Project Name: Brantford Animal Shelter

Addendum No.: 1

Enclosures: Civil Plans (Red clouded)

ROA23-003 BRANTFORD ANIMAL SHELTER

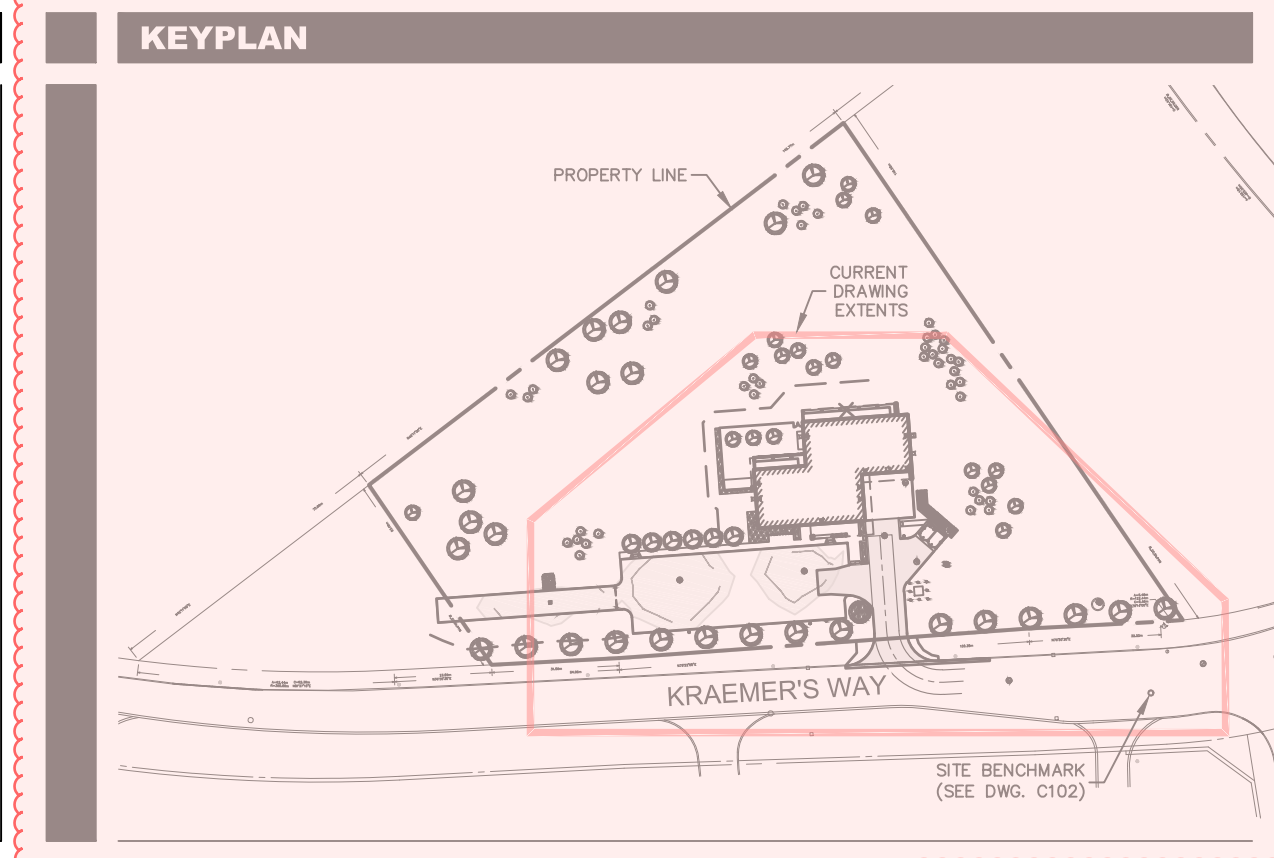
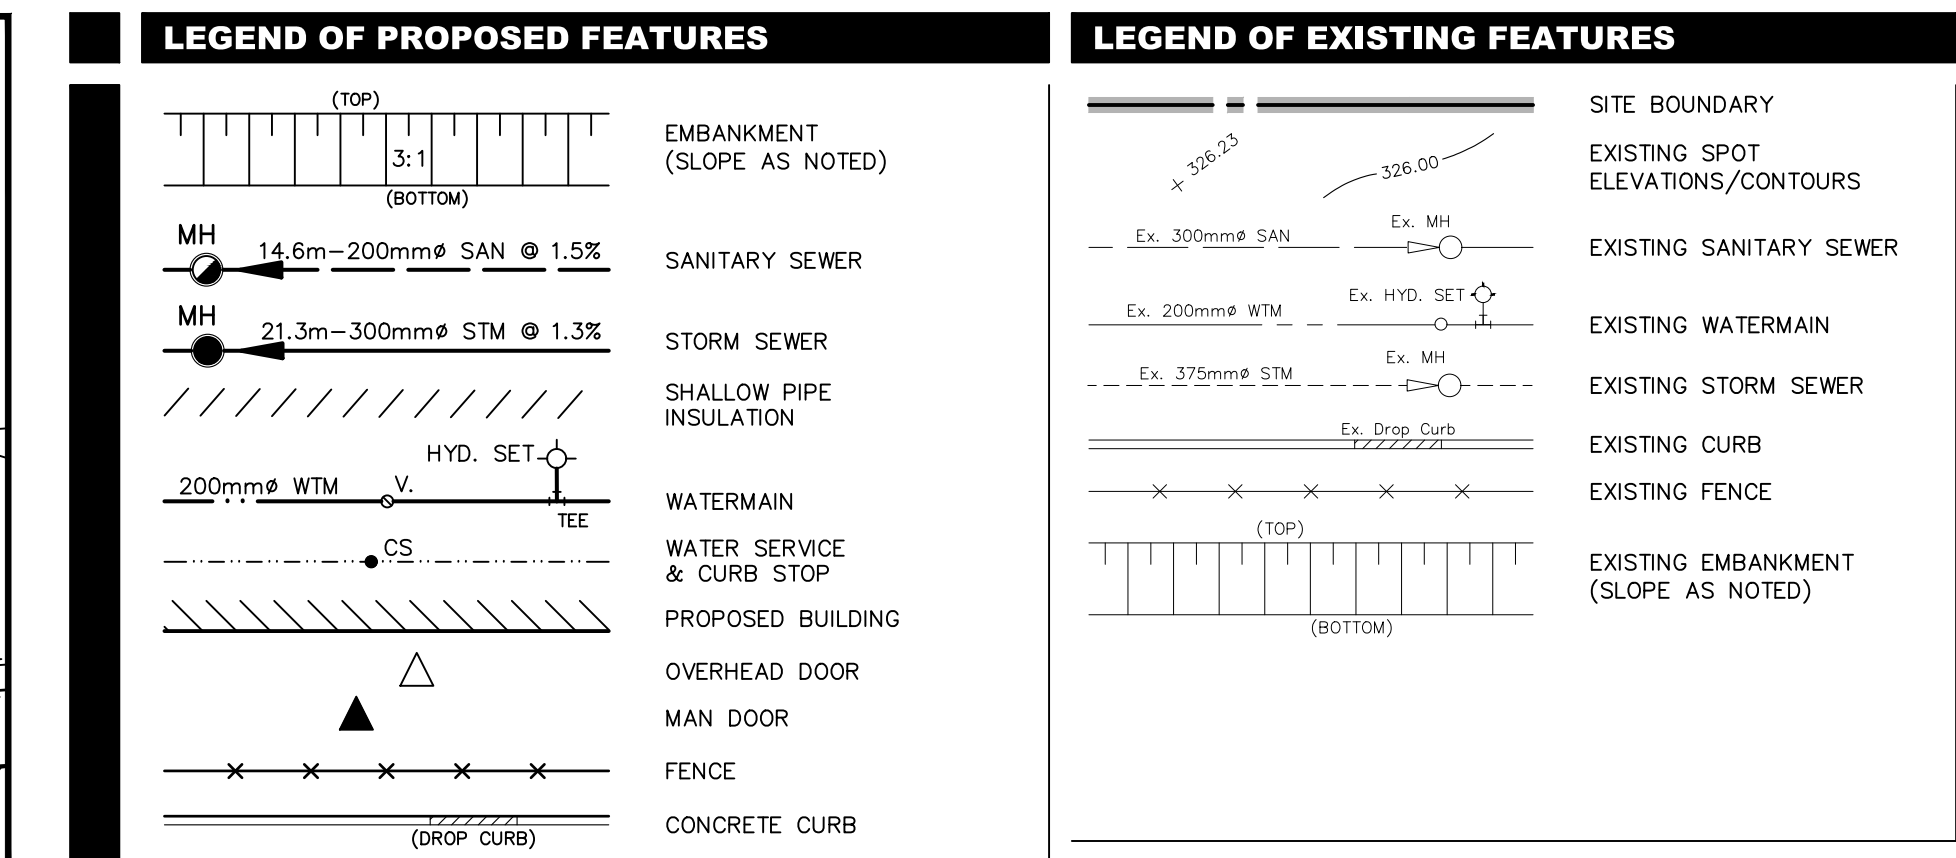
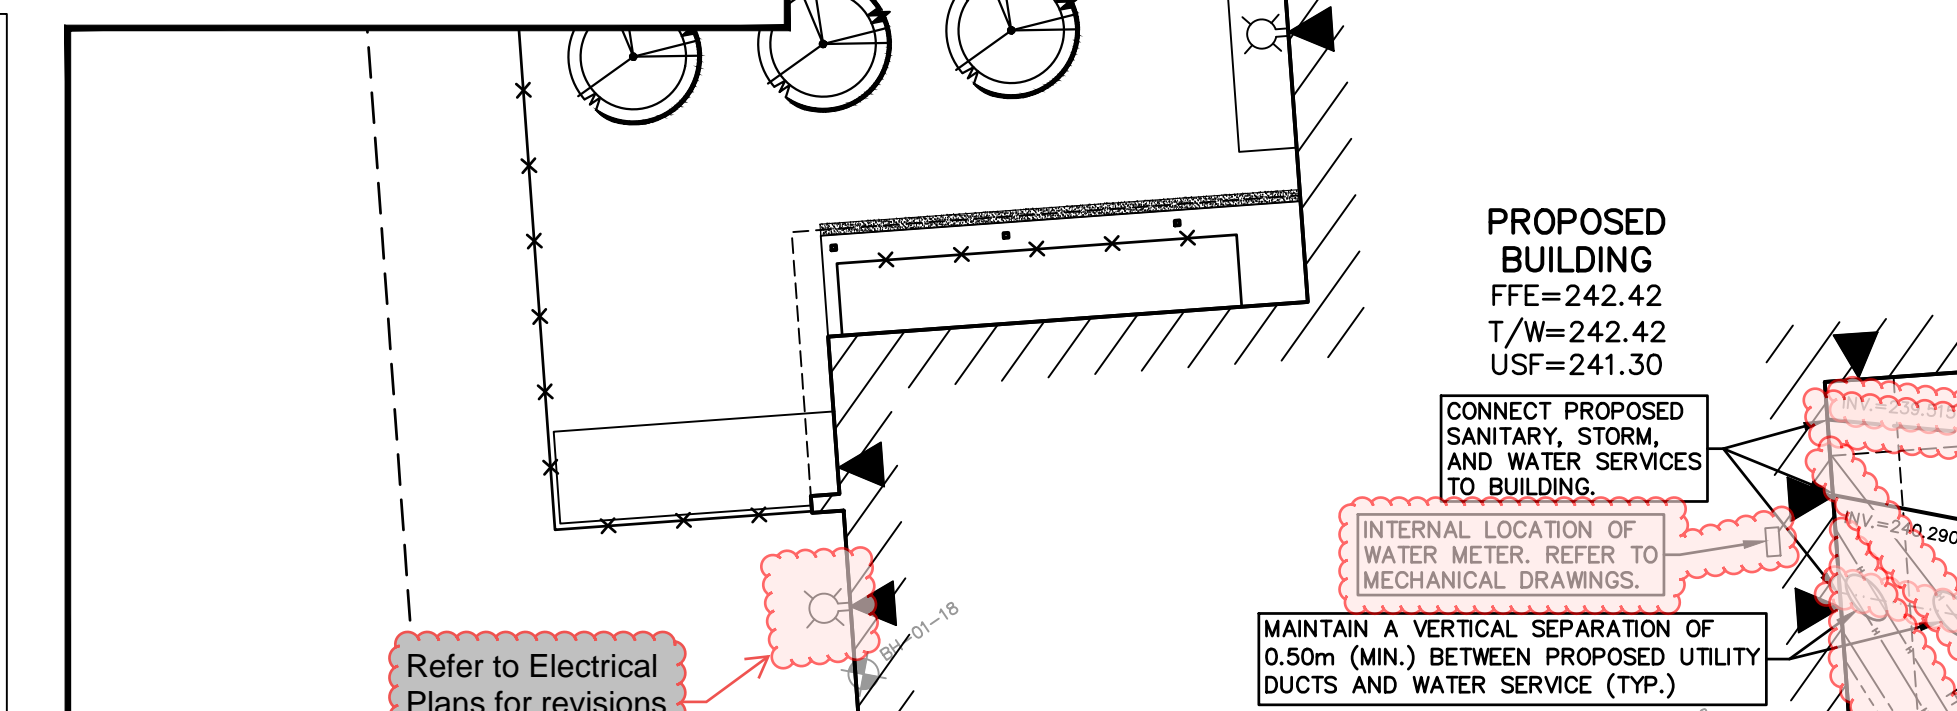
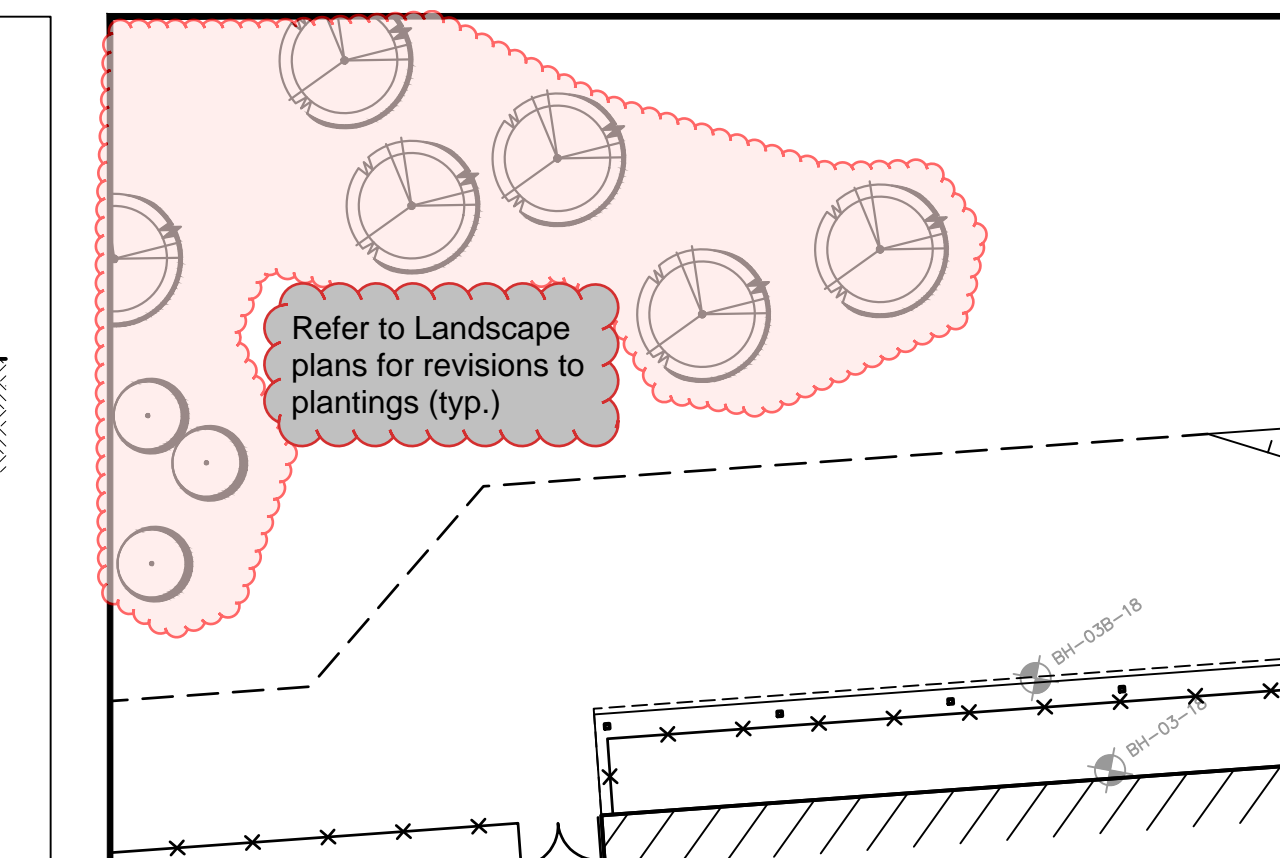
- Revised the 50mm water service to connect into the existing 200mm service for the lot (located near the southeast corner)
- Removed the proposed 300mm water main within the ROW

- There is no longer a proposed Hydrant.
- Updated the limit of construction
- Updated plan to show a bigger curb radius from the driveway to the parking lot to accommodate the garbage truck (as per revised site plan)

- Revised the grades around the revised curb area
- Made minor adjustments to the grading at the handicapped spaces near the front entrance
 - Revised the concrete sidewalk to ramp down, instead of the parking lot ramping up to the sidewalk.

- Revised the heavy duty asphalt extents to include the area used by the garbage truck to turn around
- Revised plans as per updated site plan
 - More fence around garbage disposal

- Shifted location of trees, proposed vegetation
- Revised plans to show existing curb-cut (located near the proposed entrance)
 - Labeled on C101 and noted to be restored to full height

- Added existing entrance on opposite side of Kraemer's Way
- Changed the site benchmark
 - The previous one is a manhole lid that appears to be covered in asphalt and concrete curb as it doesn't show in Google Maps

- Added Key Map to C101 and C102 drawings
- Revised the legends on C101 and C102 to better match with the ROA templates
- Shifted notes and legends and details around in paperspace of C101 and C102

- Added more grade points and slope labels to C101 as per comments.
- Updated the crossing notes on C102
- Added dimensions between water service and other servicing as per comments

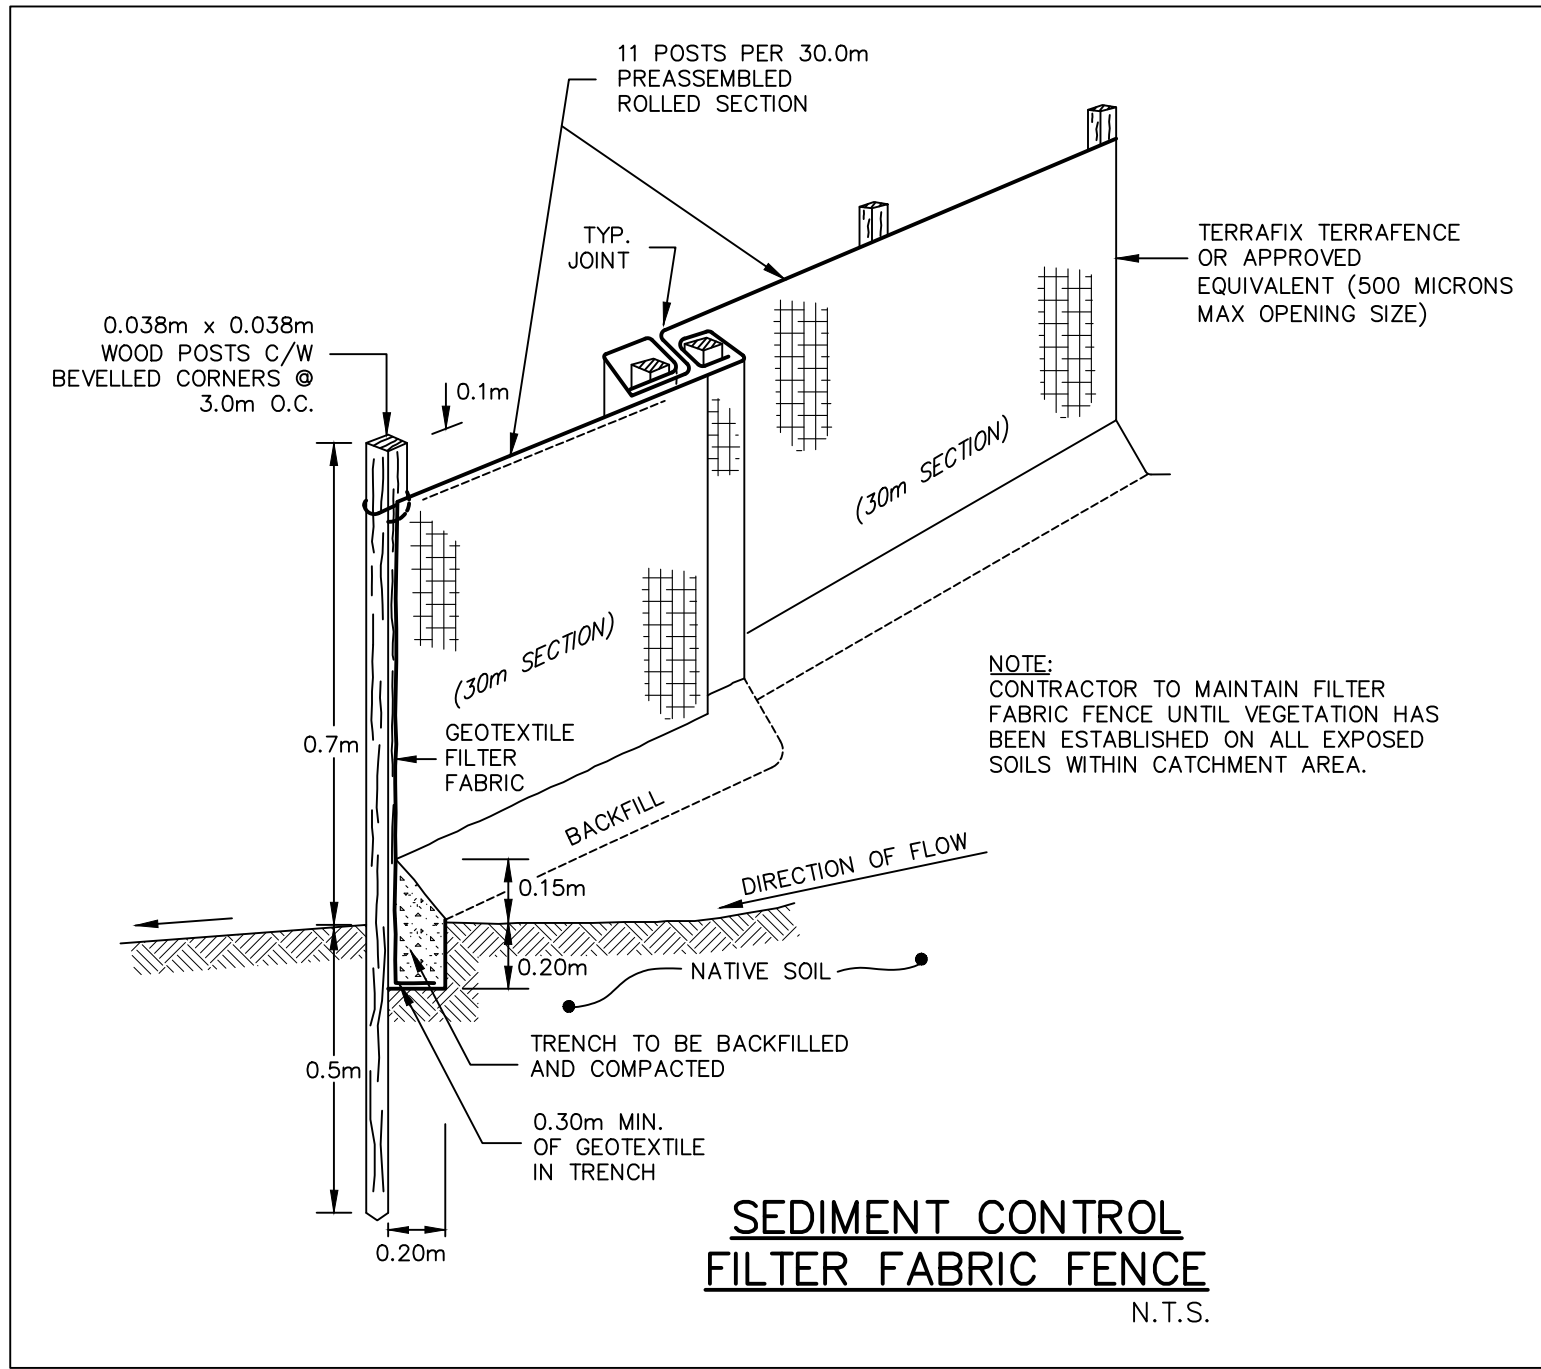
Point 4.11 removed from previous drawing set.
